**Subject: Advanced Driver Assistance Systems Draft Research Test Procedures
Docket No. NHTSA-2019-0102**

On behalf of The BMW Group, BMW of North America, LLC (BMW) appreciates the opportunity to provide comments in response to NHTSA's Request for Comments regarding the Advanced Driver Assistance Systems Draft Research Test Procedures.

Figure 1: Simulation for Field of view of a state-of-the-art fusion sensor system (camera/radar)

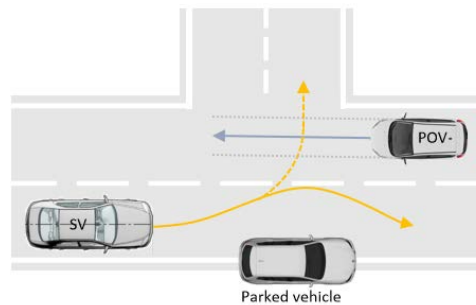
From BMW's perspective, this test procedure describes an extraordinarily complex driver assistance scenario for state-of-the-art sensor configurations due to the restriction of the detection range by the lead vehicle in front and given speeds. Therefore BMW would like to give additional comments after further investigation, which might exceed the actual commenting period.
